# A d d e n d u m

Iowa Department of Transportation  
Office of Contracts

<b>B.O.</b>	<b>Proposal ID</b>	<b>Proposal Work Type</b>	<b>County</b>	<b>Project Number</b>	<b>Addendum</b>
102	06-2186-053	PCC PAVEMENT - REPLACE	BENTON	STP-U-218-6(53)--70-06	16JUL102.A02

TYPICAL SECTIONS  
 WEST 13TH STREET

Make the following change to Plan Sheet B.02:

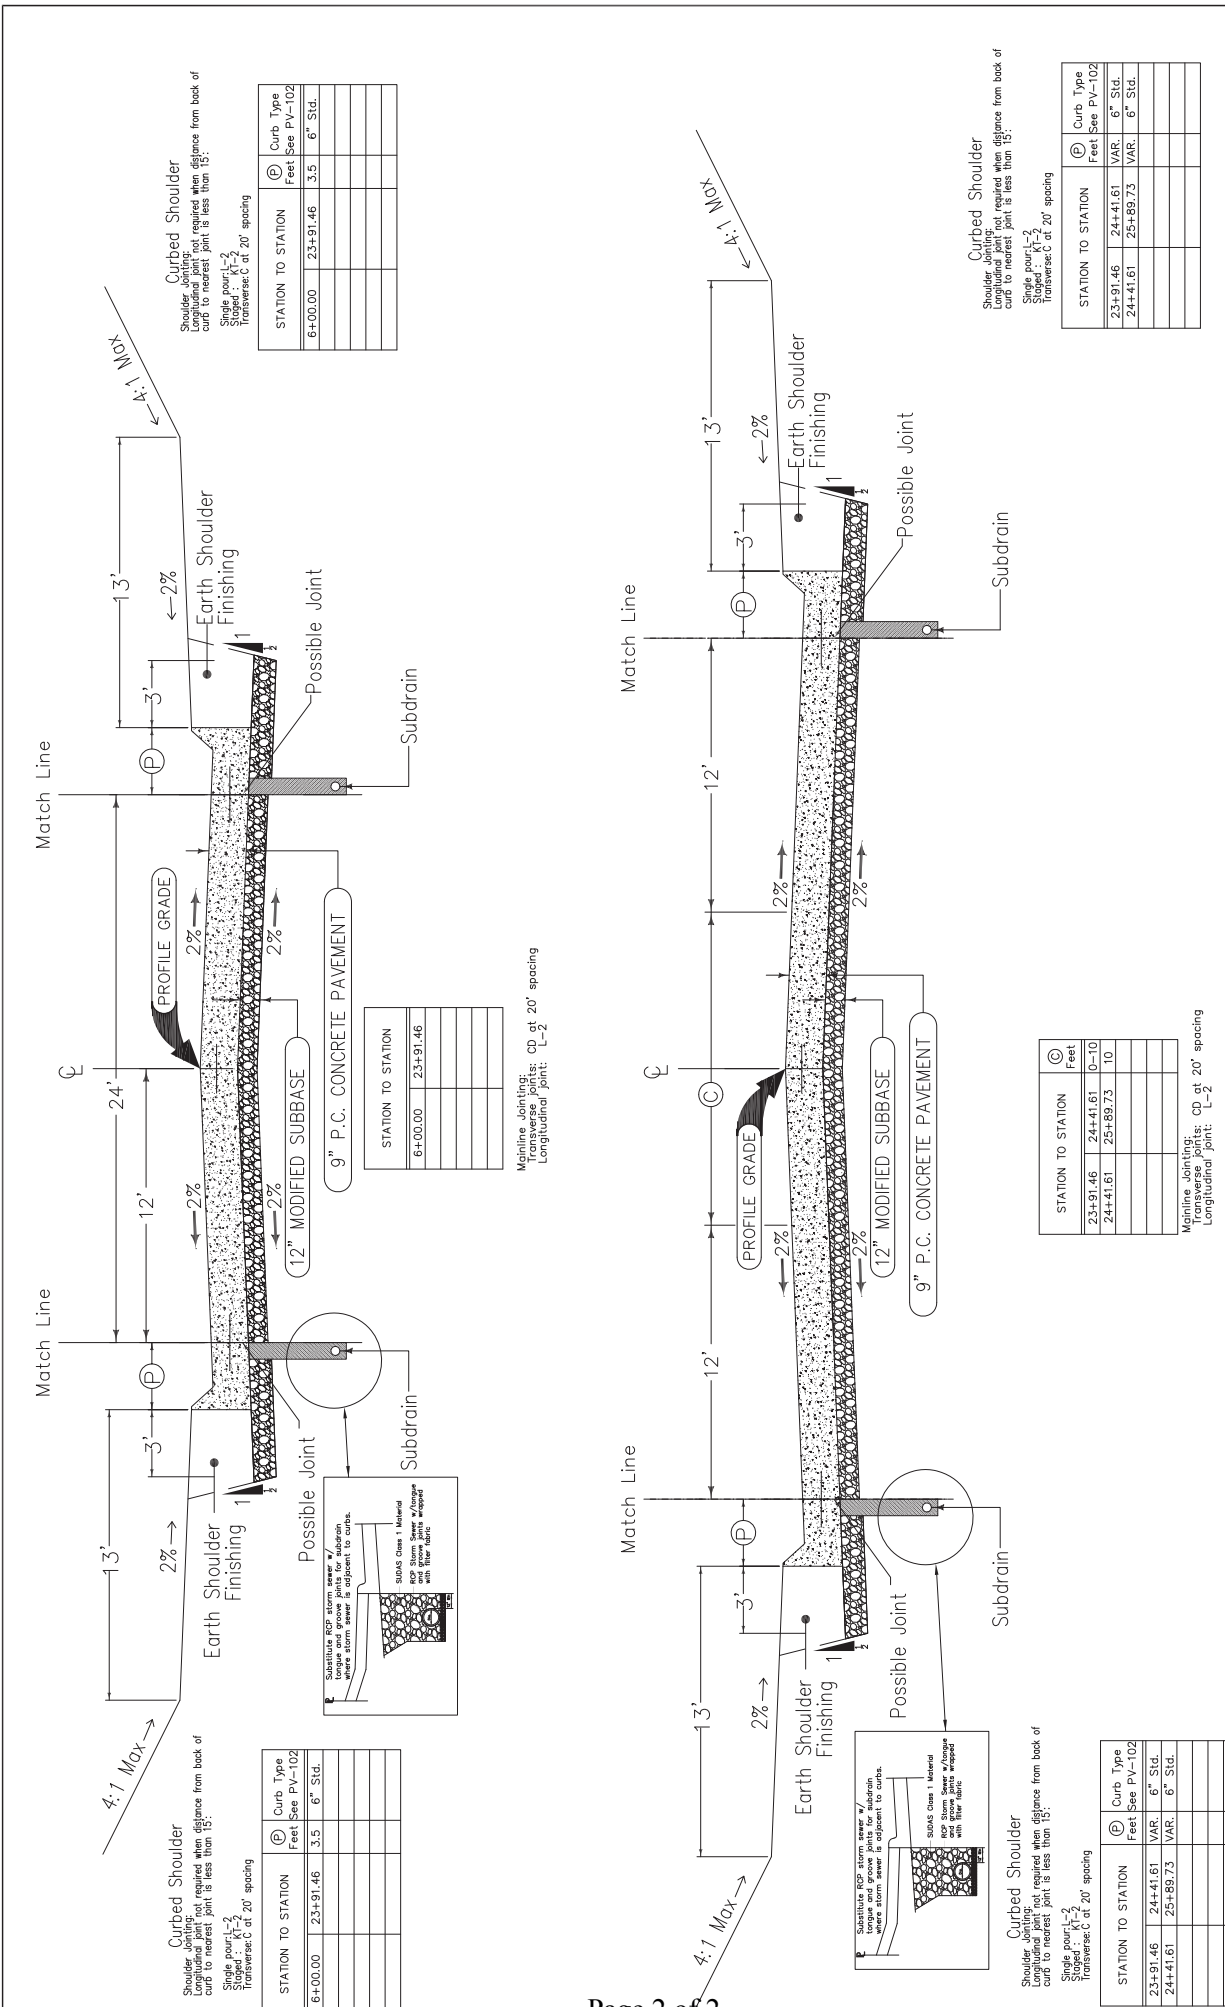
Replace Plan Sheet B.02 with the attached Plan Sheet B.02

REVISIONS: DATE: 7/20/2013 DESCRIPTION: REVISION LANE TO MATCH SHEETS
